# Proposed Changes to ZOAC Recommendations

M. Novotny  
March 7, 2011

**1) ZOAC Residential Recommendation # 5:** Eliminate the setback bonuses for houses built on substandard lots.

### R1-B Substandard Lot Example – 40' Wide

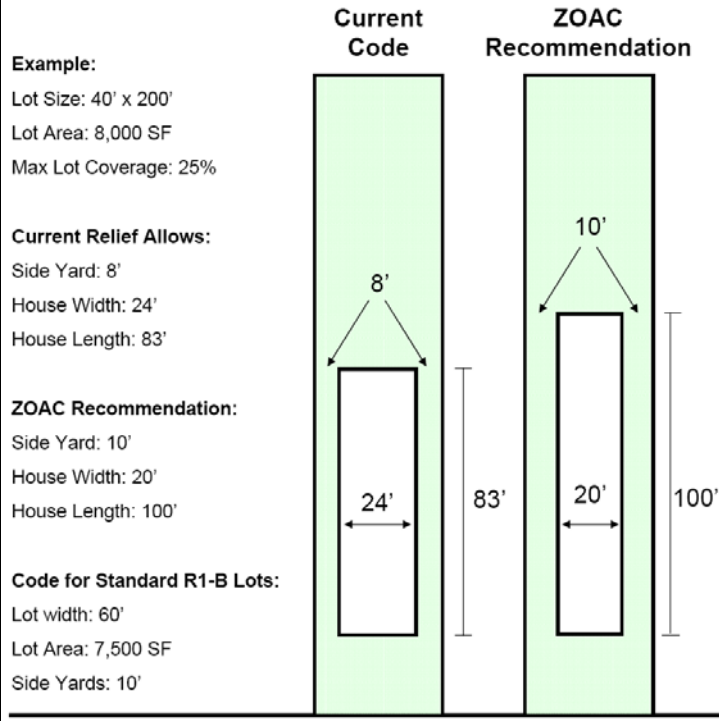
- Perhaps more importantly, this recommendation will make new homes even narrower than is currently permitted, which I don't believe was intended by the group. For example, a 40' wide R1-B substandard lot is currently permitted to have a 24' wide home. If the setback relief is eliminated, that same home would be reduced to **20' wide**. (See examples on pages 2).
- There remains an issue that under the current code a substandard lot "by area" can receive side yard setback reductions even if its "width" is conforming, and a substandard lot "by width" can receive rear yard setback reductions even if its "area" is conforming. The revision below addresses this.

Removing setback relief will create narrower homes on substandard lots. The proposed revision preserves needed side yard relief on a prorated basis.

**Prorate side yards based on actual lot width and prorate rear yards based on actual lot area (similar to how height is currently prorated). Setbacks would be reduced proportionately based on how close a lot is to being standard.**

- Sec. 48-1102 (b) (2) a. A substandard lot's minimum side yard ~~may be reduced to not less than 20 percent of the lot width, but not to less than 7½ feet in any case~~ shall be determined as a ratio of actual lot width to the required lot width multiplied by the maximum allowable side yard in the underlying zoning district. However, the substandard lot side yard shall not be less than 7 ½ feet in any case.

### R1-A Substandard Lot Example – 50' Wide

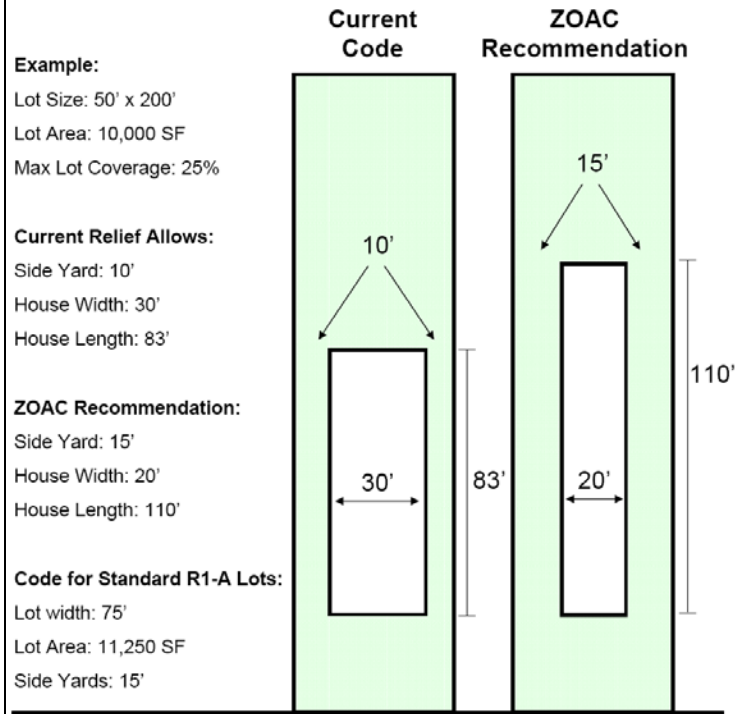
Removing setback relief will create narrower homes on substandard lots. The proposed revision preserves needed side yard relief on a prorated basis.

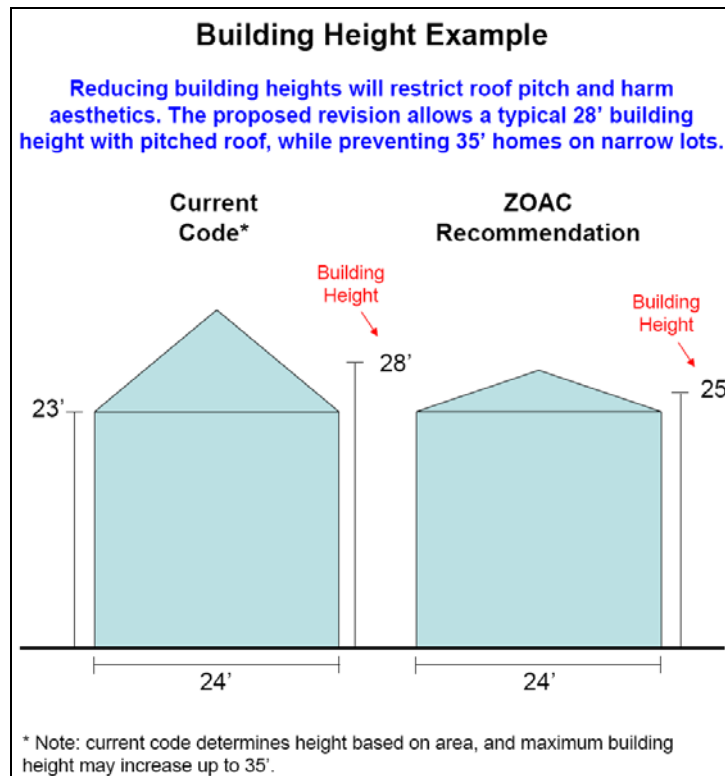
- This is a positive recommendation, however it requires one important adjustment regarding minimum building height.
- Most new two-story homes need a building height of at least 28' (\*may need up to 30' – 31' if lot is sloped) which allows for sufficient floor-to-floor height and an adequately pitched roof. Going below 28' in height will lower the roof pitch and make the home less aesthetically pleasing. (See example below)

- The ZOAC recommendation will push more lot owners below 28' in height. Specifically, any substandard lot owner with a 60' wide lot or less in R1-A and 48' wide lot or less in R1-B would be required to build below 28'. In each of these cases, homeowners will likely avoid gable roofs and instead opt for lower pitched or flat roofs.

- The minimum height should be adjusted from 25' to at least 28' to meet current construction standards and avoid the introduction of low or flat roofs.

**In addition to the ZOAC recommendation, change the minimum building height for substandard lots from 25' to 28' to meet current construction standards and avoid negatively impacting the exterior design of a new home.**

- Sec. 48-1102 (b) (2) c. The substandard lot building height shall be determined as a ratio of actual lot area to the required lot area or actual lot width to the required lot width, whichever is the lesser percentage, multiplied by the maximum allowable height in the underlying zoning district. However, the substandard lot building height shall not be required to be less than ~~25~~ 28 feet.
